REVIEW OF WATERFORD III BASEMAT ANALYSIS

Structural Analysis Division
Department of Nuclear Energy
Brookhaven National Laboratory
Upton, NY 11973

June 21, 1984

Fig. 1 LOCATION OF ELEMENTS LISTED IN TABLE 1

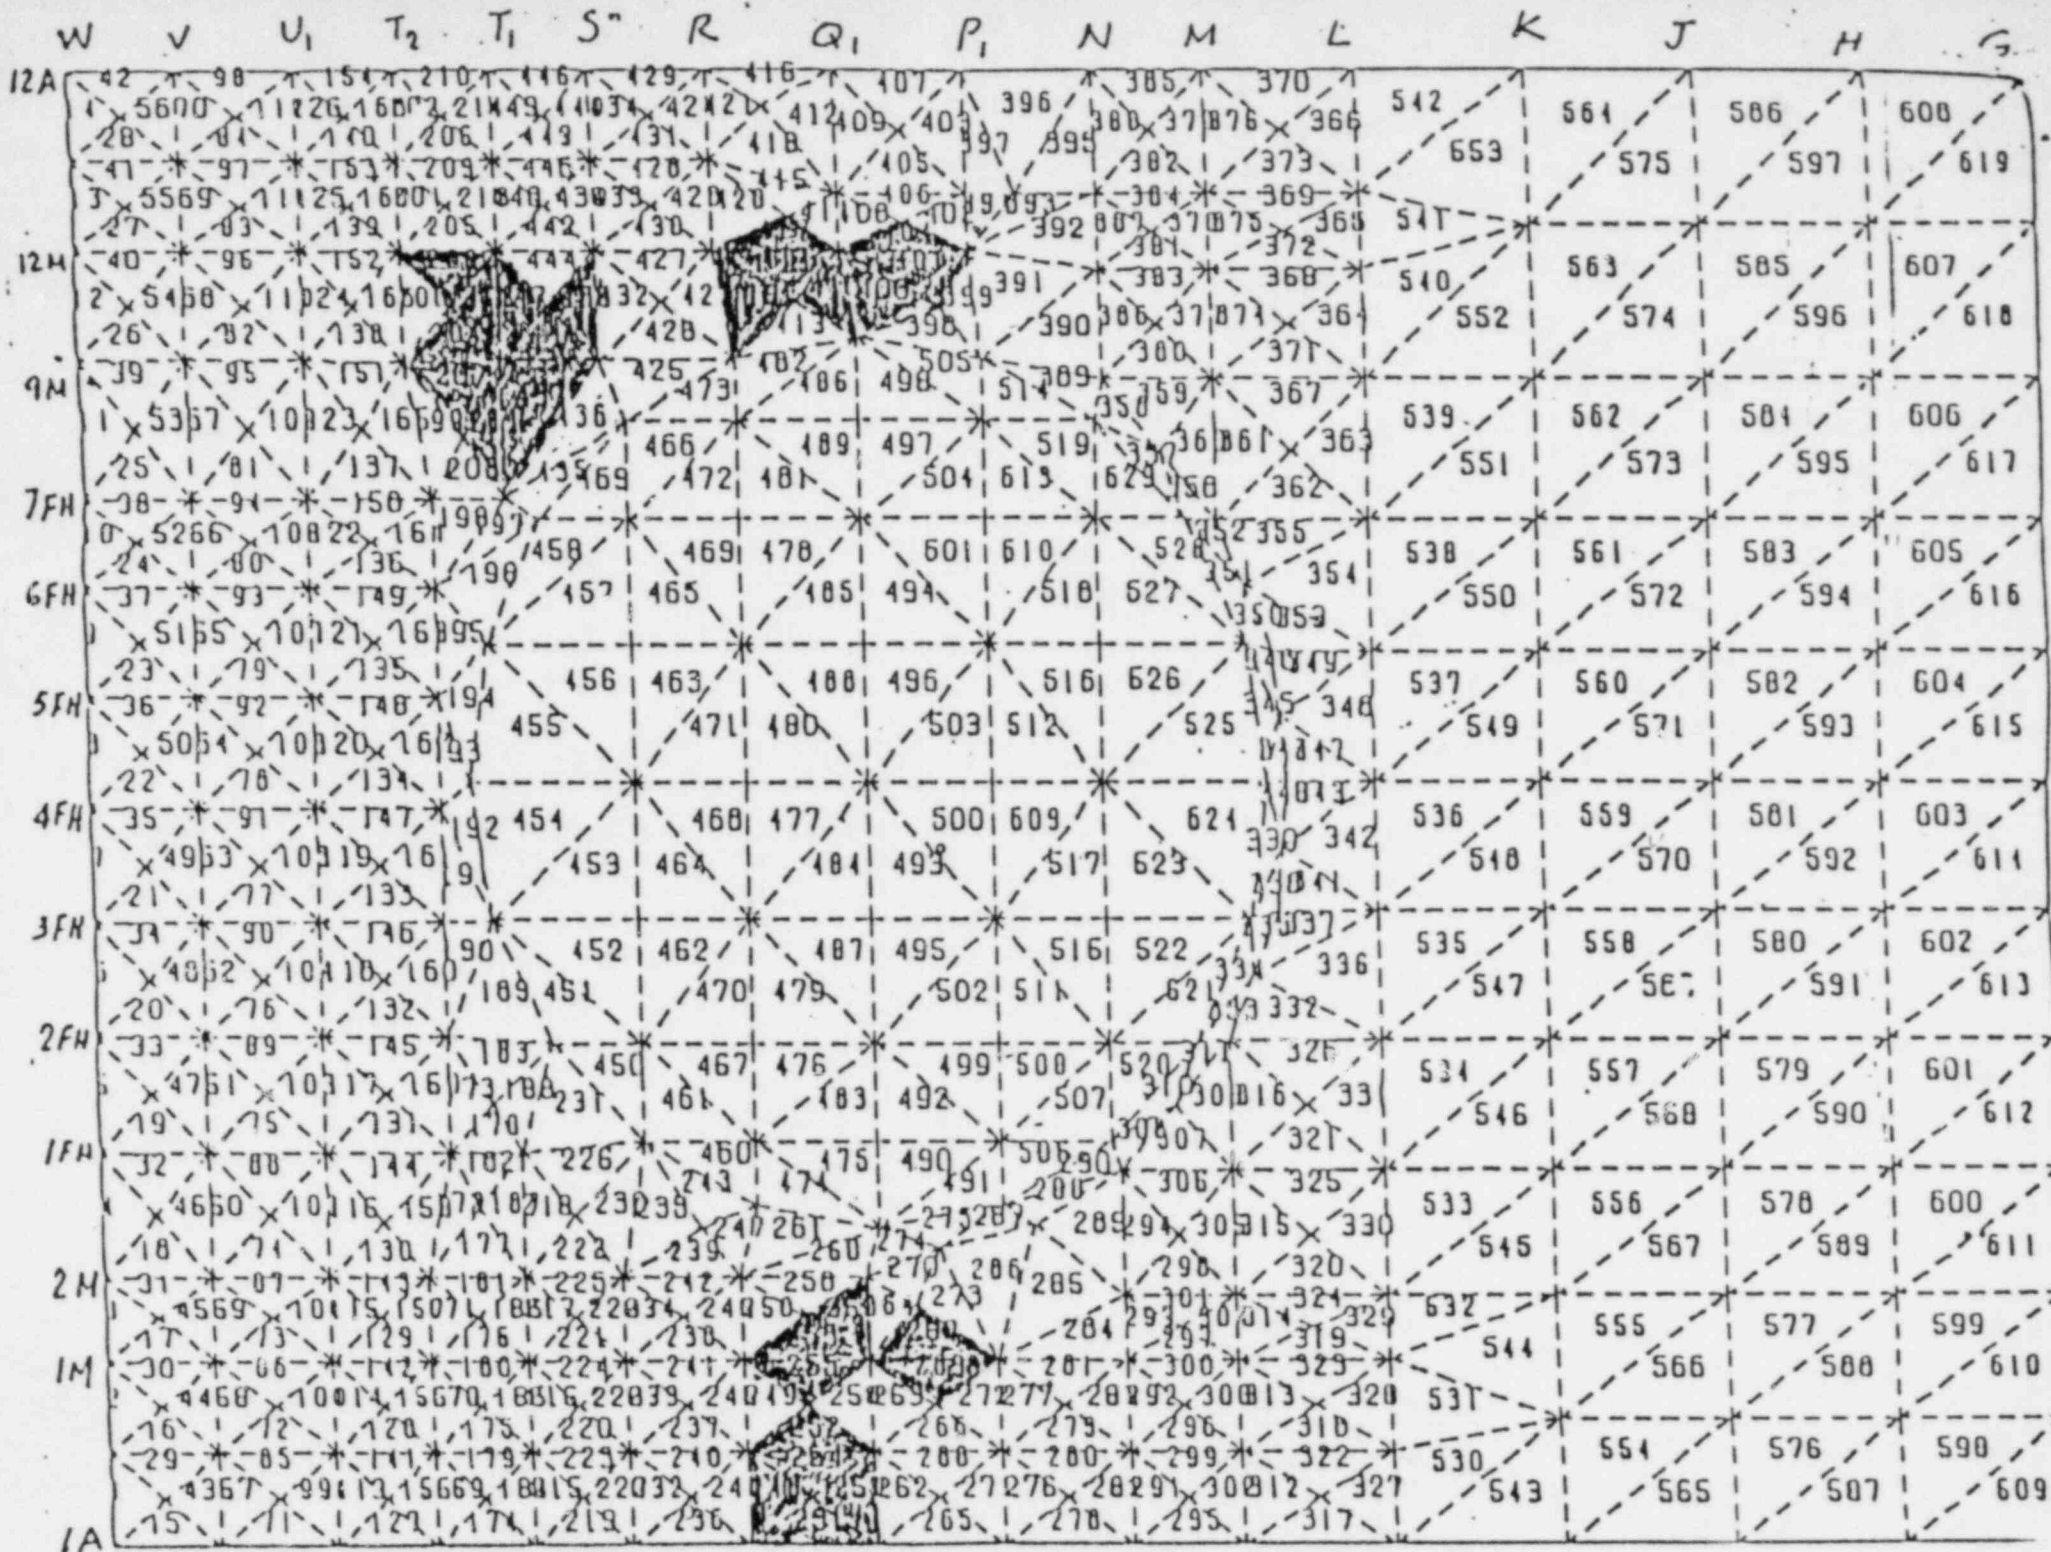
As mentioned, EBASCO in their discussion and HEA in their reports have not shown analytically, the cause of the top surface cracks. In reviewing the HEA computer outputs, it was found that element moments and shears for individual loadings are explicitly given. Thus, for the case involving dead loads only, a number of elements in the cracked regions exhibit moments (positive in sign) that can produce tension and thus create cracking on the top surface. This situation is shown in Table 1 which gives moment data (M_x , M_y and M_{xy}) for elements under various load conditions (dead (D), buoyancy (B) and normal side pressure) in some of the cracked regions. The particular elements are also depicted by the shaded areas shown in Fig. 1.

In view of the comments made in a later section in this report regarding the finite element grid size and hence, their effects vis-a-vis, the accuracy of the results, an approximate analysis of a strip of the mat was made. This strip was taken at the center of the reactor building in the N-S direction with a width of 22 ft. In this analysis the mat was considered to be infinitely stiff and subjected to the dead loads taken from the HEA computer input. The maximum moment for this case (i.e., 3450 ft-kips/ft) occurs close to the center of the reactor and indeed results in tension on the top surface. This magnitude exceeds the cracking capacity of the mat which is in the neighborhood of 1764 ft-kips/ft. Somewhat lower but similar results would occur at the other cracked sections shown shaded in Fig. 1.

The additional east-west direction top reinforcements will also cause prevailing cracks in elements located directly east and west outside of the shield wall circle (i.e., those shown shaded in Fig. 1 in areas R-P-2M-1A and R-P1-12A-9M) to be oriented in an east west direction. This is indeed the pattern indicated in Fig. 3. Since there is no additional top reinforcement in the elements shown shaded in Fig. 1 located between sections T2-R-12-7FH, the prevailing cracks do not necessarily have to be oriented in the east-west direction.

Fig 2 MAT REINFORCEMENT

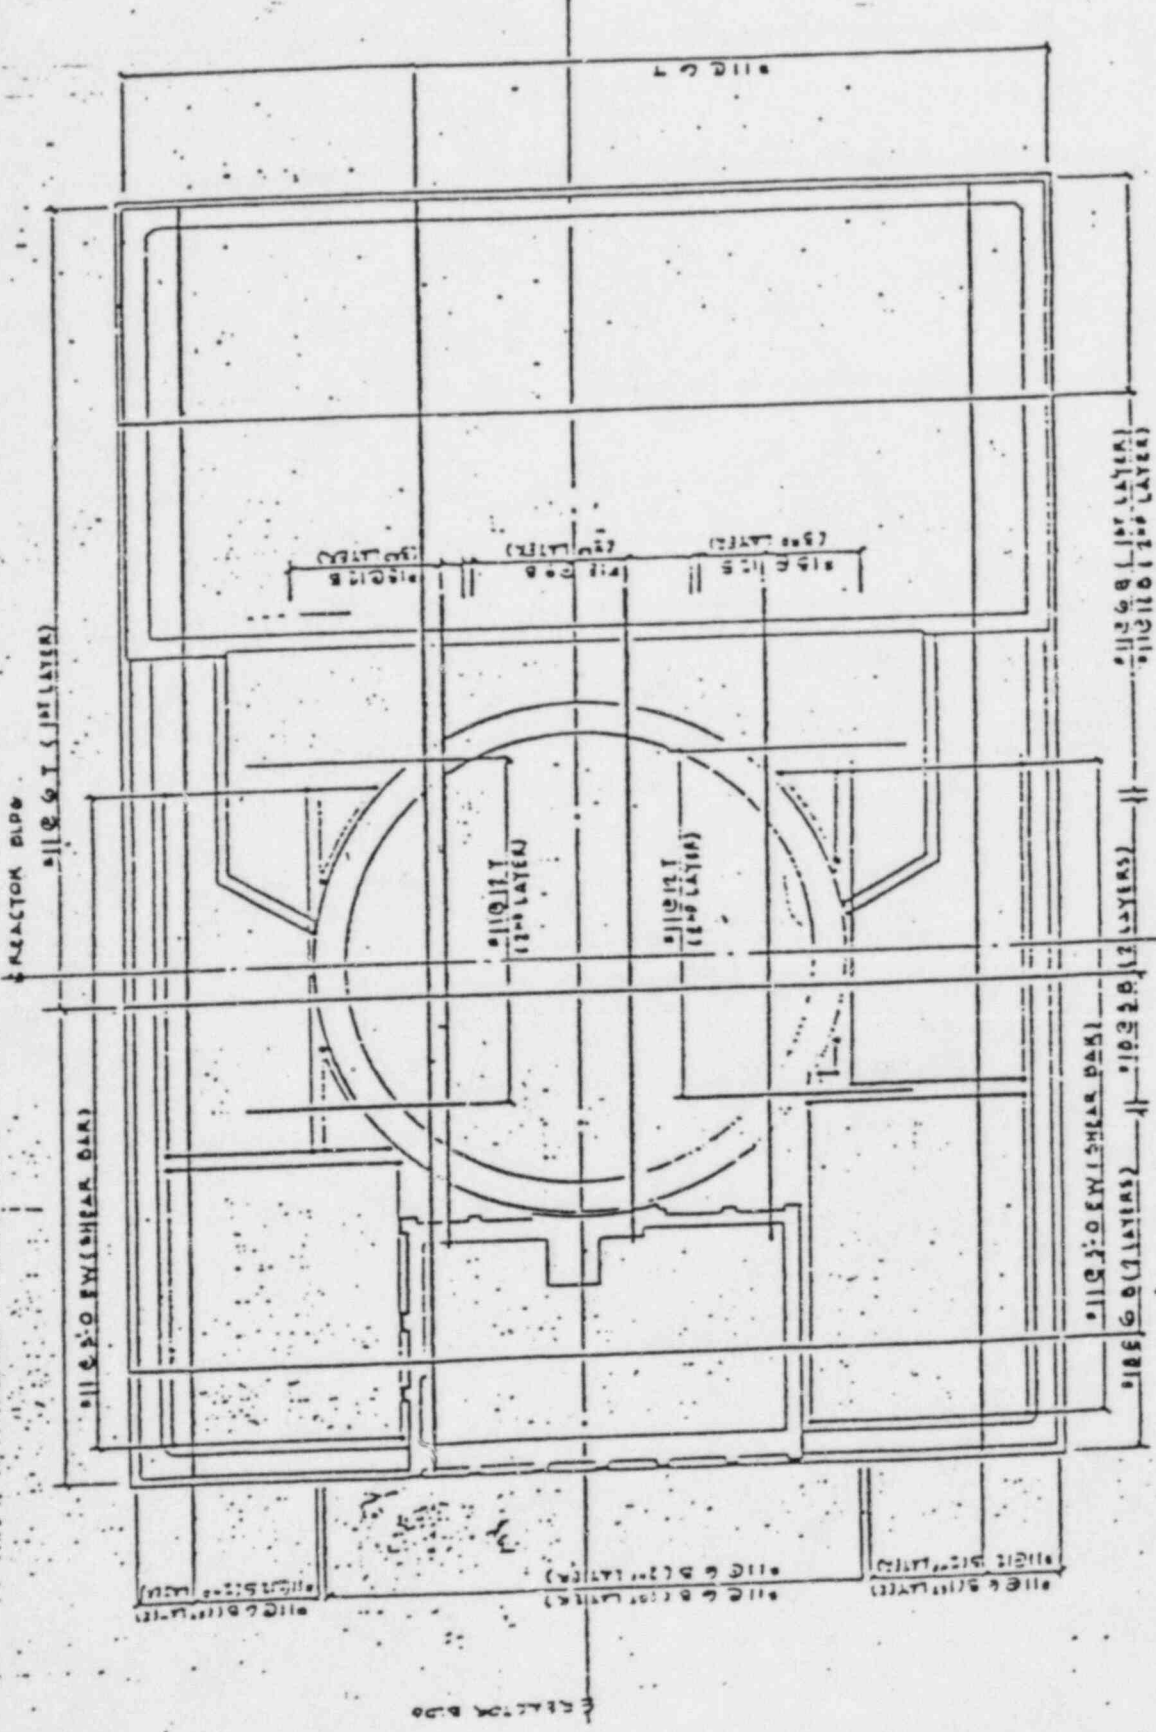
*In a subsequent phone conversation, P.C. Liu of EBASCO stated that some additional reinforcement was added on the top surface in one direction. This was verified in the sketch depicted in Fig. 2 given to BNL by EBASCO where certain areas of the mat are shown strengthened with additional #11 bars are placed every 12 miles in the east west direction.. Even if this is the case the statement that follows is true for the unstrengthened direction and probably even for the strengthened direction.

Fig. 3 CRACK MAPPING PER
 RE/GN 9-11-83 to 9-2-83
 for HEA, IUC (ADB)

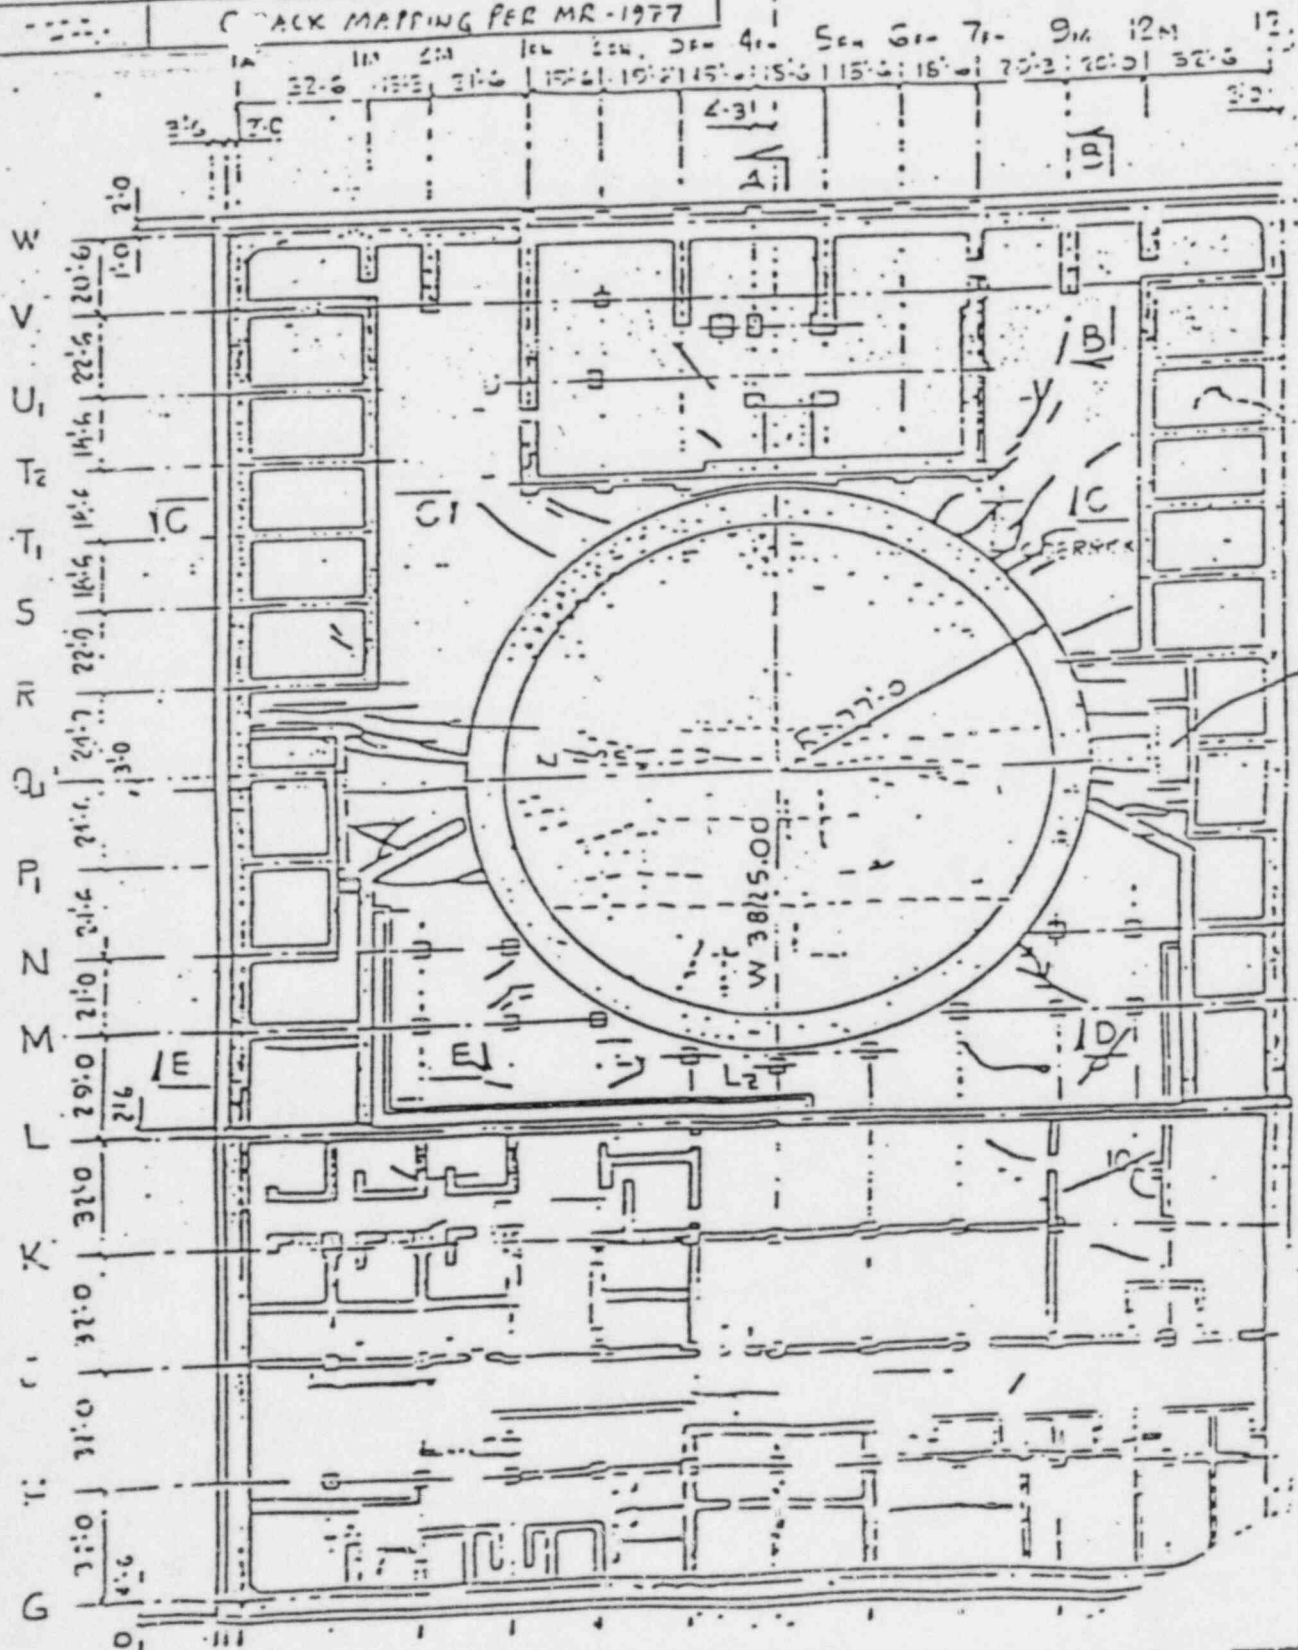
As shown in Table 1 and in Fig. 1, the discussion thus far only pertains to cracks outside of the shield wall. As shown in Fig. 3 crack patterns were also noted in March of 1977, internal to the shield wall. At that time the shield wall was partially constructed up to elevation 187' and the steel containment was supported on temporary footings. Other walls or structures on the mat were either not as yet constructed or were only partially constructed. Since the computer dead load calculations refer to the mat with all existing structures, it is not possible to utilize the computer results to explain the 1977 cracks. It should be pointed out however, that the additional top reinforcements (i.e., # 11 @ 12" shown in Fig. 2) are essentially located in areas under the shield wall and are placed in an east-west direction. Thus, if cracking should occur the preferred direction would

be parallel to the direction of the heavier reinforcement. This is indeed the direction of the cracks. They could be due to curvature during construction and dead loads acting in conjunction with thermal and shrinkage effects.
